VISIT TO THE CONSTRUCTION SITE OF A HOUSING PROJECT
IN PANGNIRTUNG, BAFFIN ISLAND, N.W.T.

This report is a record of some of the observations and subsequent discussions of the design and construction problems concerned with providing housing in Canada's North.

DBR INTERNAL REPORT NO. 459

Fig. 5. Construction details of wall-floor section
(taken from building drawings)

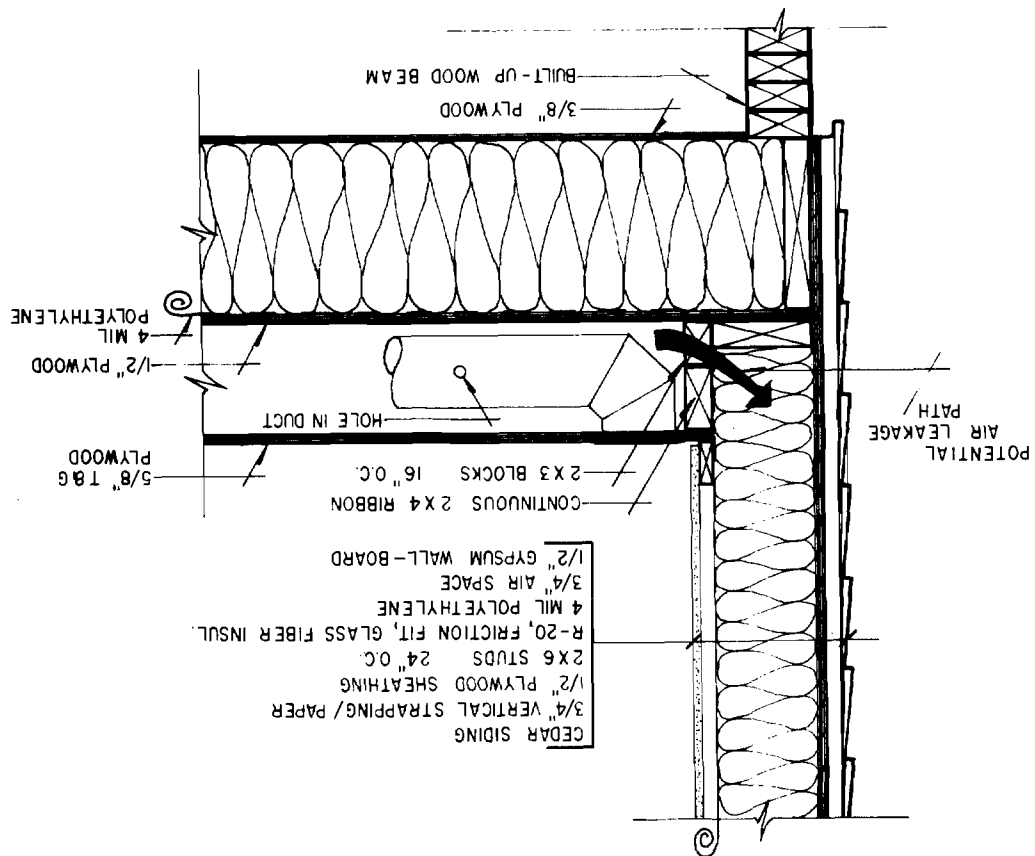
On the morning of 1 December 1978, Mr. Perreault and I continued our examination of the buildings, especially those whose constructions were most advanced. We discussed the pressurized base and the problems it could lead to, the 19 mm cavity behind all drywall, the use of plywood as exterior sheathing and the multitude of holes created by chimneys, plumbing and wiring. We concluded that pressurizing the floor cavity could lead to serious condensation problems, either in the insulation of the floor or in the wall cavity defining the perimeter of the building. In addition, it was discovered that three of the 16 units had 38 x 53 x 250 mm spacer blocks instead of a continuous 38 x 53 mm ribbon around the perimeter, thereby creating gaps at least 25 x 250 mm leading directly into the outside wall cavity behind the polyethylene sheathing (Fig. 5). The harshness and long duration of the winter can make even a minor air leak a serious problem; openings of this size might well cause the exterior walls to fill with condensation in a matter of weeks. To avert this potential problem, Mr. Perreault and the field superintendent decided to insert 38 x 140 mm wood blocks between the studs and complete the seal by caulking. To reduce further the risk of air leaking into the wall, it was recommended that additional outlet grilles be installed in the floor to relieve cavity pressure. Further discussion of this problem with Mr. Pierre DeCourval revealed that such pressure relief had been intended and was specified but the necessary hardware was not available. The intent was to install specially designed grilles in which forced warm air from the duct outlet would draw floor space air by venturi action. This would have assured a continuous flow of air in the false floor, thereby maintaining the intended uniform floor temperature at a minimum air pressure difference.

In principle, the object of constructing a service cavity between drywall surfaces and the structure is commended, but in practice it may lead to far more air leakage than if the drywall had been applied directly over the structural elements. Since the cavity between the drywall and the structural elements is continuous between the walls and roof surfaces, any openings on the interior are now connected to any other opening on the exterior regardless of the location of each one. Therefore, the probability of air leakage through the building is very high in comparison with a construction technique which would cellularize or compartmentalize the building envelope as occurs when the drywall is applied directly over the structural elements.

(A) - high-lift prefabricated wood truss; (B) - insulation detail

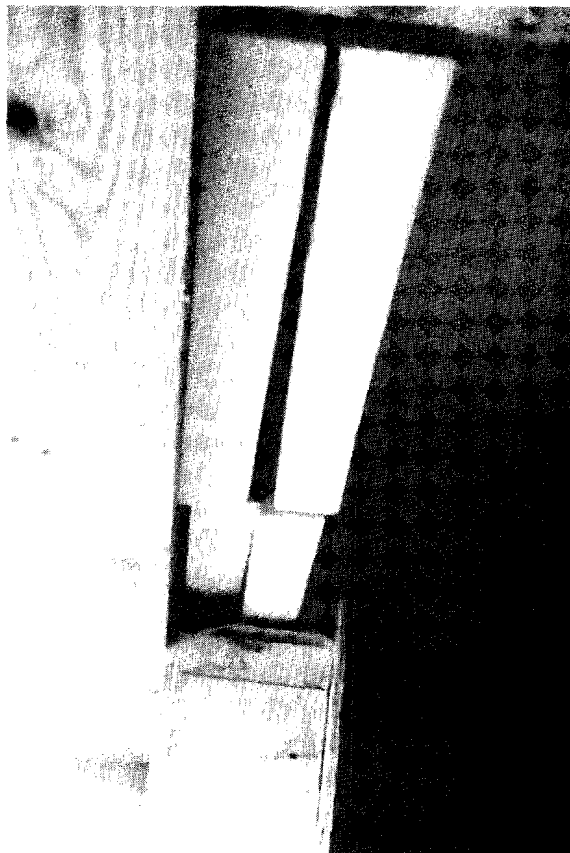
Plans for the Pangnirtung project specified polystyrene insulation in two layers on the inside of header joists at certain areas. Inspection of this detail, however, revealed large gaps between the insulation and the header, a practical difficulty when rigid insulation is used for this purpose (Fig. 6B). Air circulating in this space will probably negate the intended effect of the insulation. Even if the insulation had been nailed or glued to the joist surface, its application would still be questionable.
